Village of Lemont
Planning & Economic Development Department

TO: Committee of the Whole
FROM: Charity Jones, AICP, Planning & Economic Development Director
SUBJECT: Case 13-11 Birch Path Final PUD Plan/Plat Amendment
DATE: April 8, 2015

BIRCH PATH P.U.D.
127TH & I-355, LEMONT, IL
UTILITY PLAN

BIRCH PATH P.U.D.
 127TH & I-355, LEMONT, IL
 GRADING PLAN

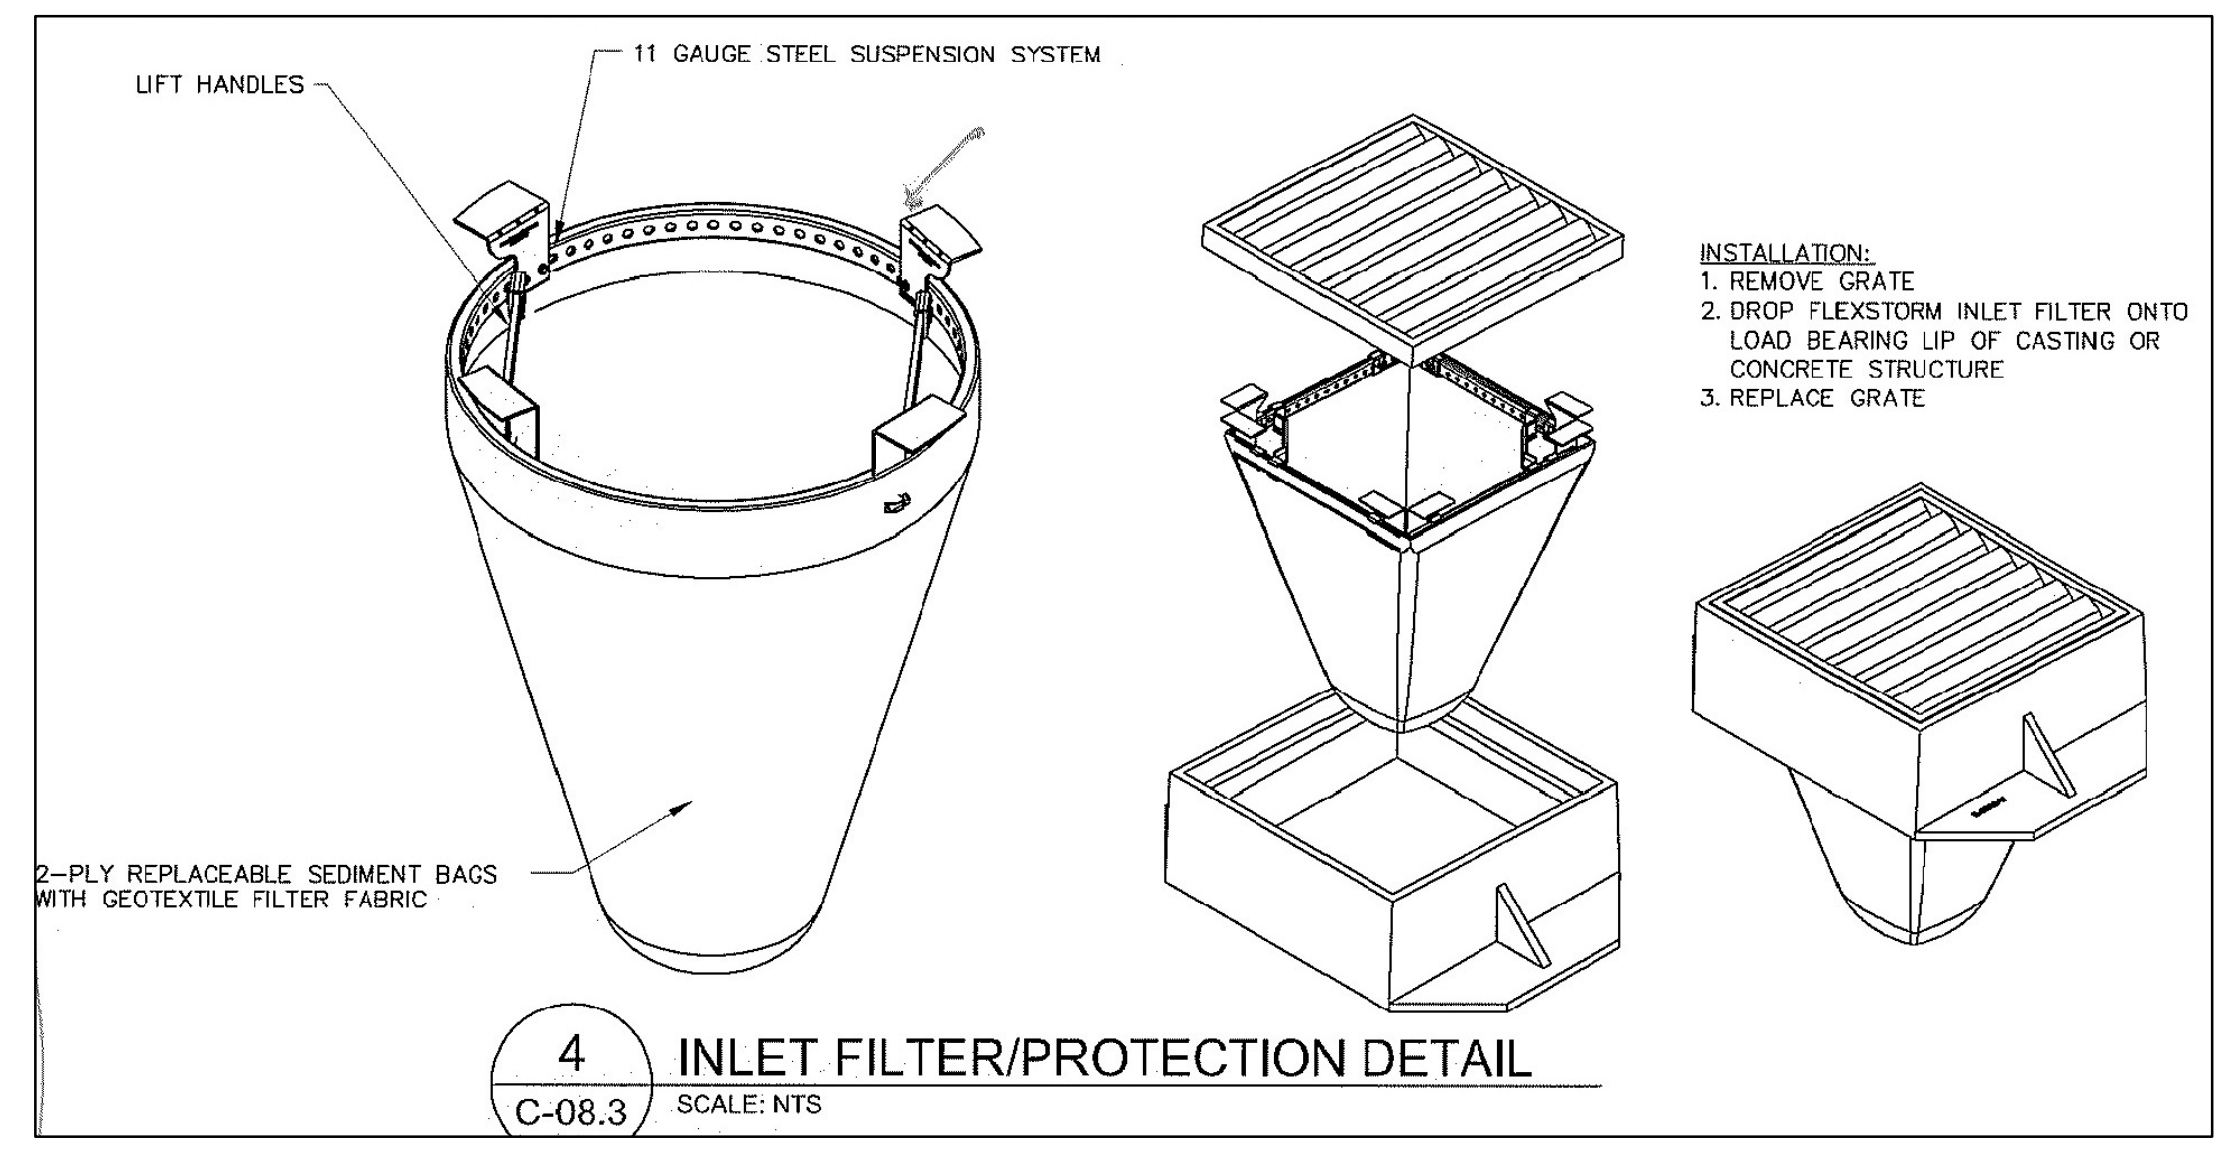
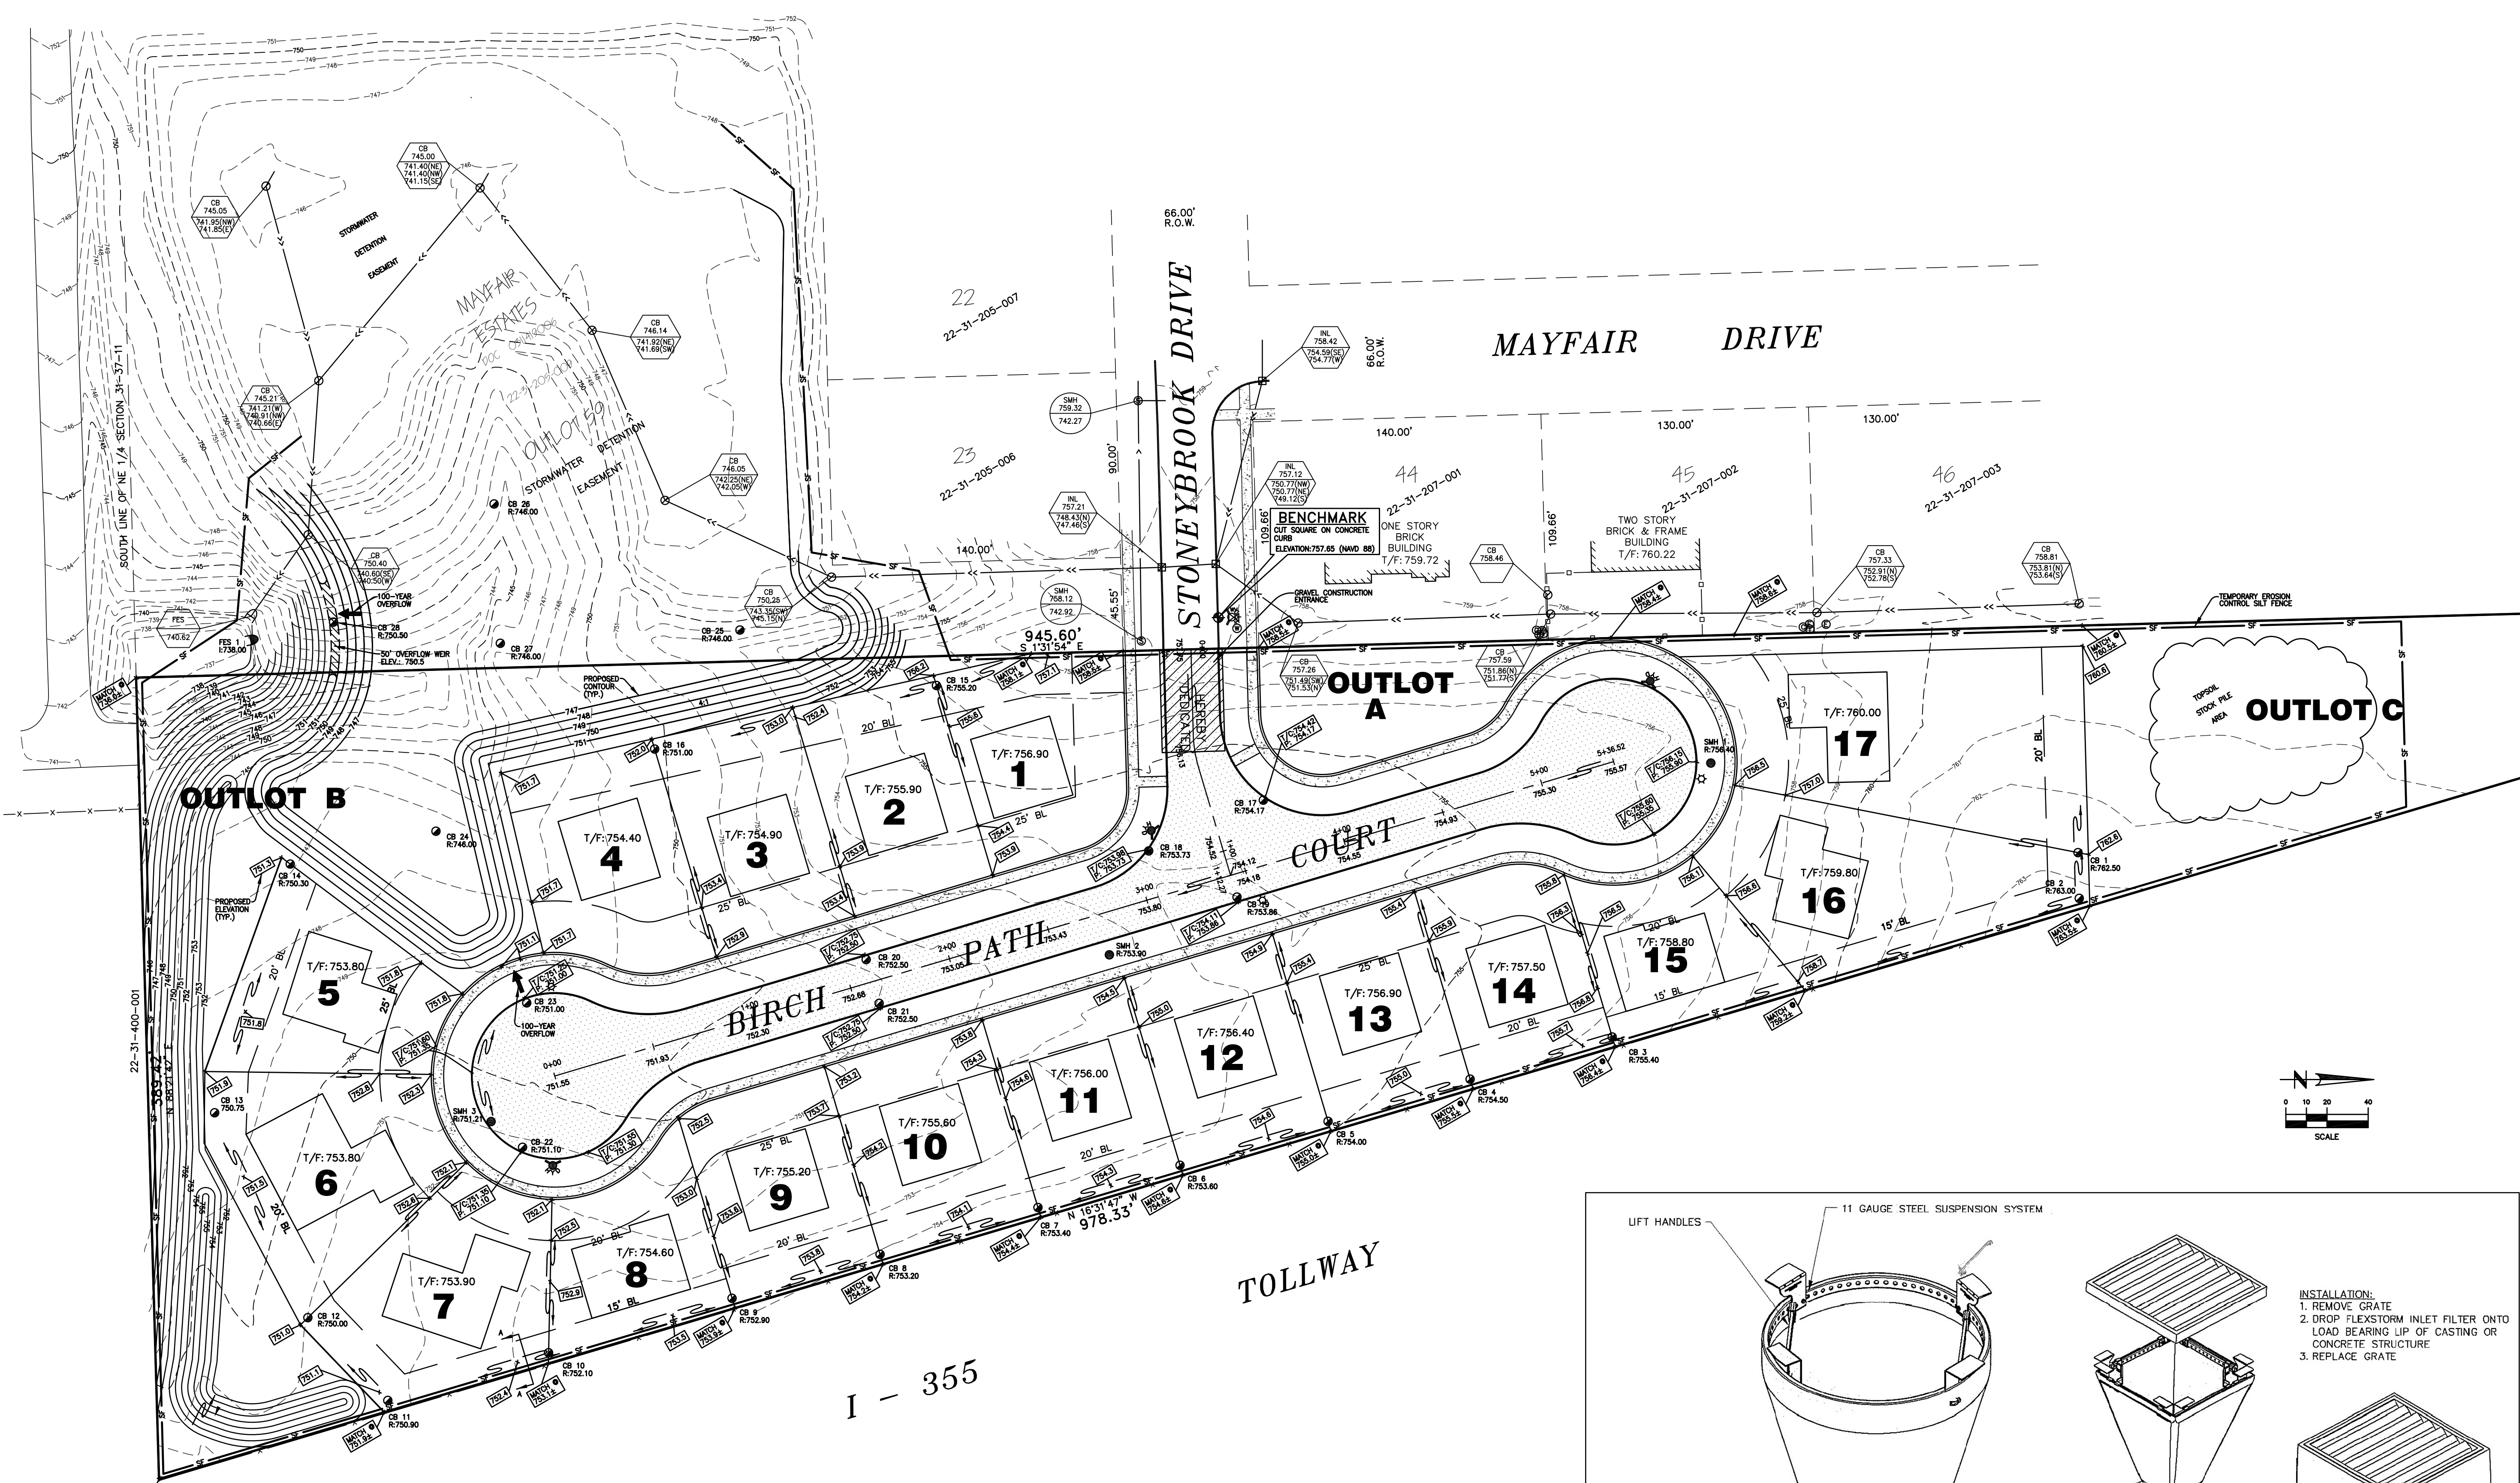
3) Note 27 on page 8 of 12 should be revised to read "Twenty-two (22) mitigation trees (6 swamp white oaks, 6 bur oaks, 6 red oaks and 4 white oaks) shall be planted in Outlots A, B & C as determined by Lemont's Arborist.
